**Statement of Compliance
Access for People with a Disability**

**Proposed Mixed Use
Development**

52-62 May Rd Narrabeena

Report Type: Statement of Compliance - BCA Access Provisions
Development: 52-62 May Rd Narrabeena

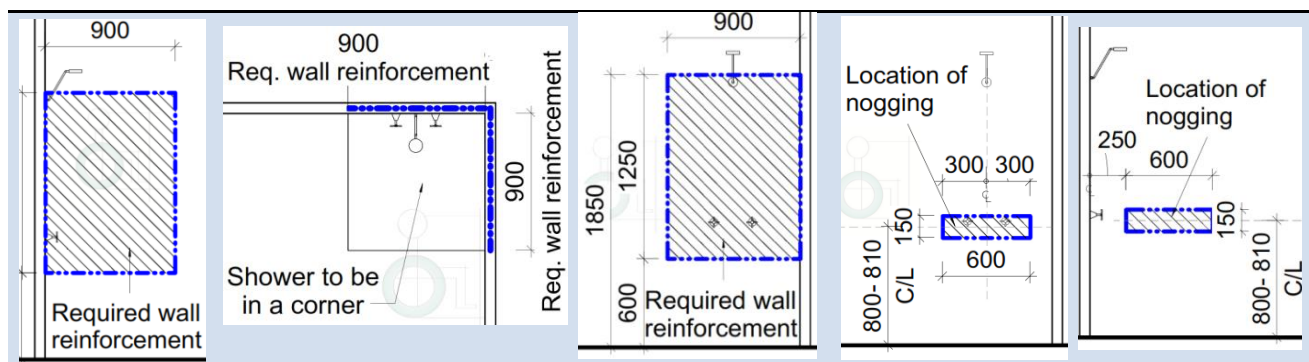
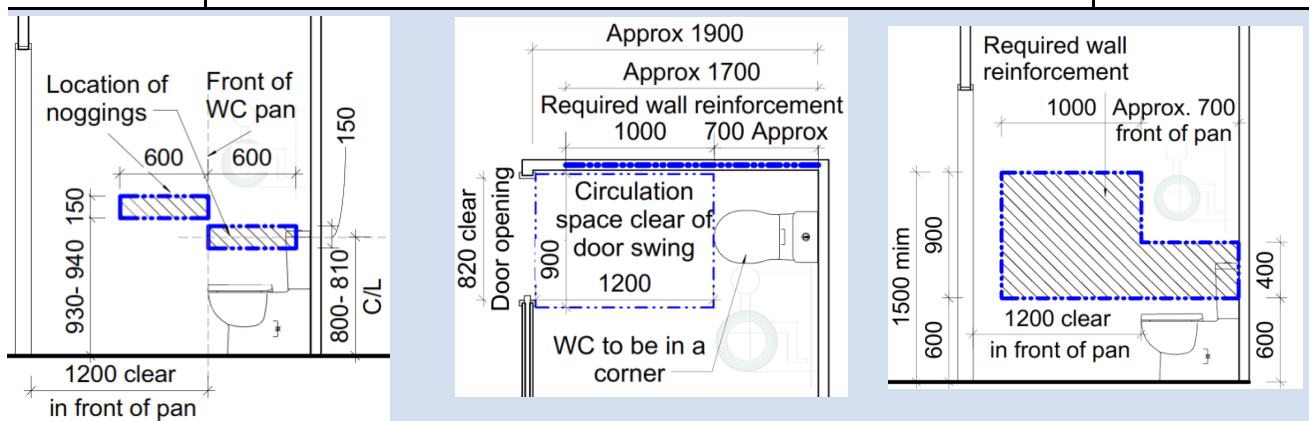
Since **2** of the units (**12 & 13**) already comply with the Adaptable unit requirements, these units are also capable of satisfying the intent of Silver level of Livable Housing Guidelines as noted in the table below.
